CITY OF BURBANK  
COMMUNITY DEVELOPMENT DEPARTMENT

November 15, 2021

**Subject:** Pickwick Gardens, SB 35 Notice of Intent Second Submittal Review

## **TRAFFIC ENGINEERING**

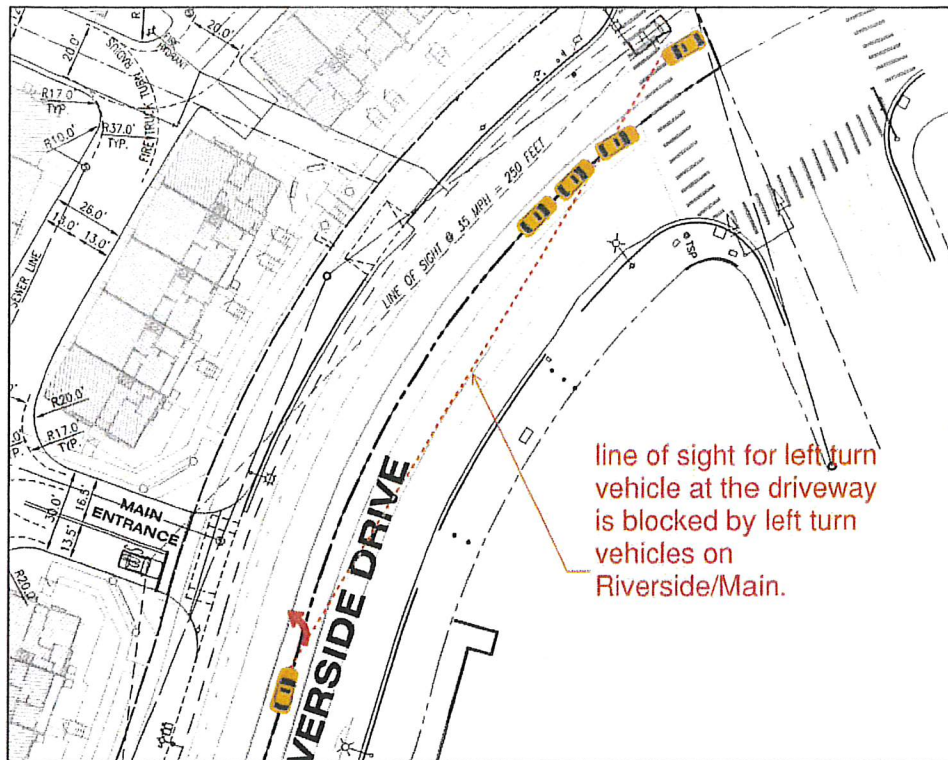
- Previous comment dated 07/22/21: "Proposed driveway on Riverside Drive is too close to the signalized intersection at Riverside/Main. The left turn movement into the proposed driveway will have poor visibility for WB through traffic on Riverside Drive and will also obstruct the traffic flow of the EB left turn movement at Riverside/Main. Developer shall move the proposed driveway a minimum of 350' west of the signal (approximately where the existing westerly driveway is) to maximize the line of sight for safer ingress and egress."

The applicant provided an exhibit, which shows line-of-sight of a vehicle turning from the main entrance and onto Riverside Dr. The main entrance is shown approx. 250 feet from the intersection of Riverside/Main, as measured along the centerline. However, this line-of-sight analysis is incorrect and does not address the previous comment. Per the AASHTO Greenbook, the minimum sight distance for vehicles turning left from the major roadway is 285'. A 285' clear line of sight, for vehicles turning left onto the property, cannot be achieved with the main entrance located 250' west of the Riverside/Main intersection. There is restricted visibility created by curvature of the roadway and vehicles queuing in the eastbound left-turn pocket at Main Street and Riverside Drive (see the exhibit below). To address these visibility constraints, the Developer shall design the driveway in one of the following ways:

- Previous comment dated 07/22/21: "Modify striping on Riverside Drive to provide exclusive left turn lane for driveway access."

If the main entrance will be moved a minimum of 350' west of the intersection, then the developer shall modify the striping on Riverside Drive to provide an exclusive left turn lane for driveway access. If the main entrance will remain in the proposed location, then the developer shall provide the proper striping and signage on Riverside Drive to restrict left turns into the driveway.

Prior to issuance of Public Works Excavation Permit, the Developer shall submit a signing & striping plan of the modified striping on Riverside Drive, to be approved by the Public Works Traffic Engineering Manager.

**EXHIBIT C**

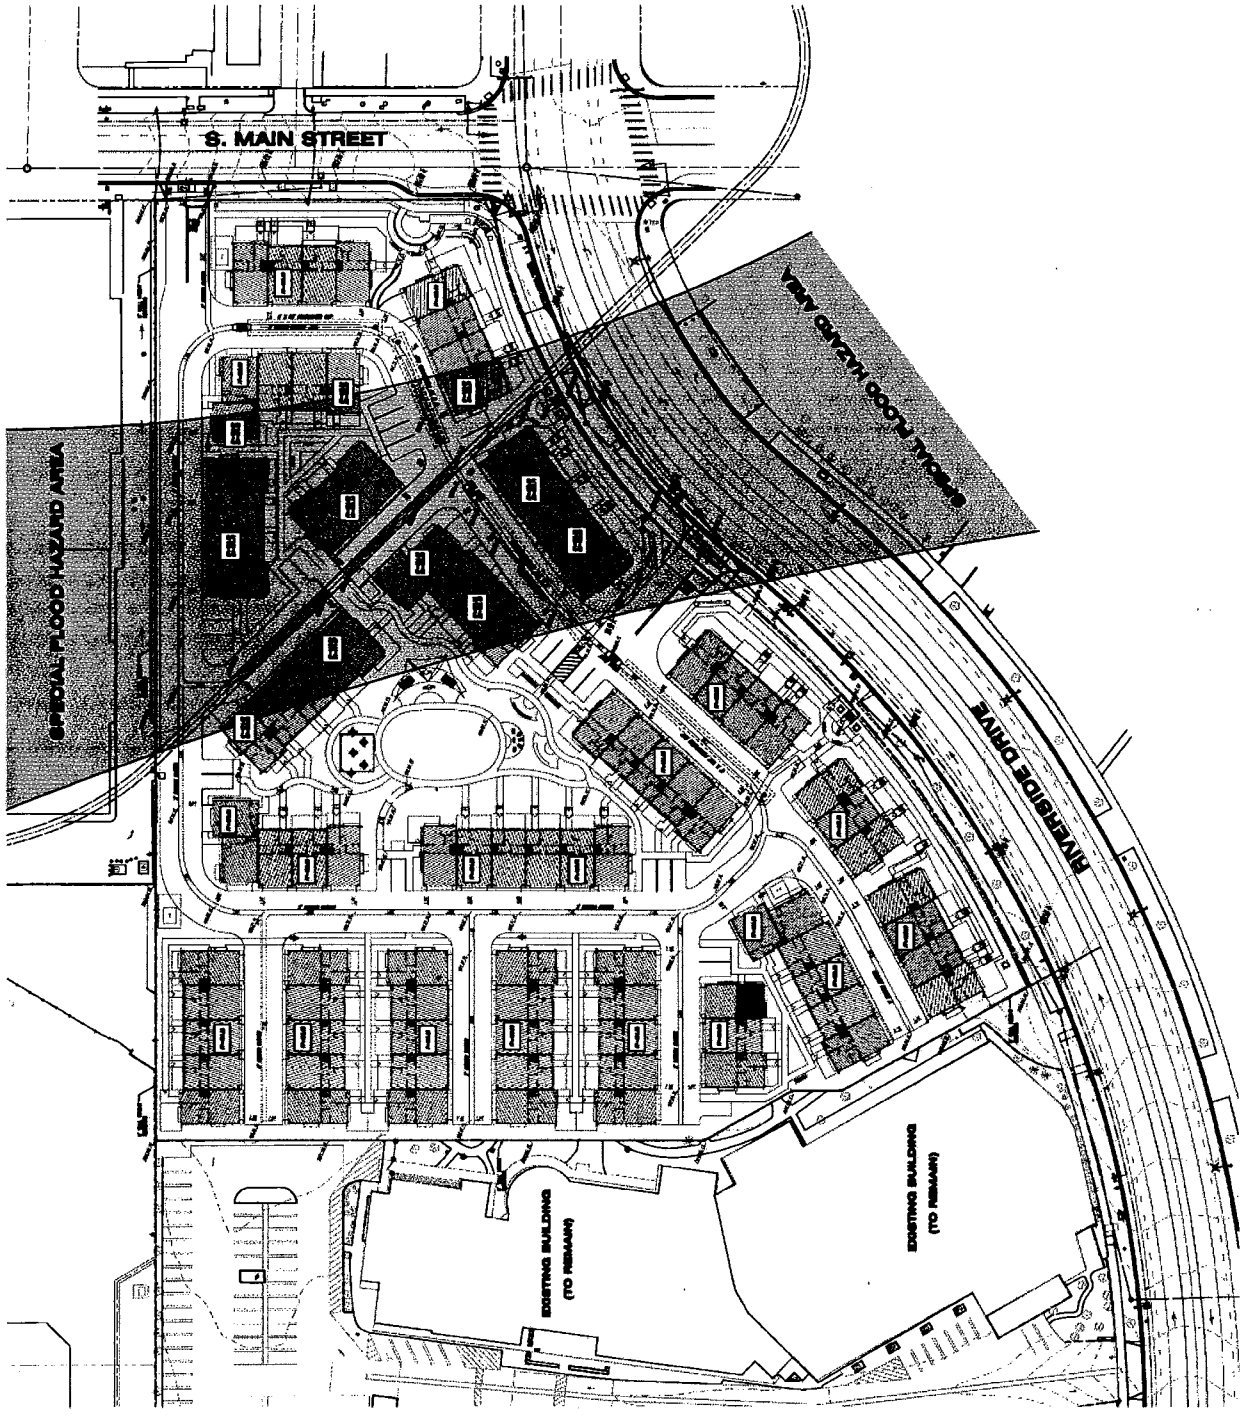
With respect to the second criterion, as shown on Exhibit C in the Project Applicant's memorandum titled "Preliminary Grading and Drainage Plan," the Proposed Project will include adequate drainage around structures on slopes, to guide storm and floodwaters around and away from the proposed residential structures. The Proposed Project will include slopes of 2% or more grade away from structures. With this proposed infrastructure, the Proposed Project will provide adequate drainage around structures on slopes to guide storm and floodwaters around and away from proposed structures. As such, the Proposed Project will comply with the second criterion.
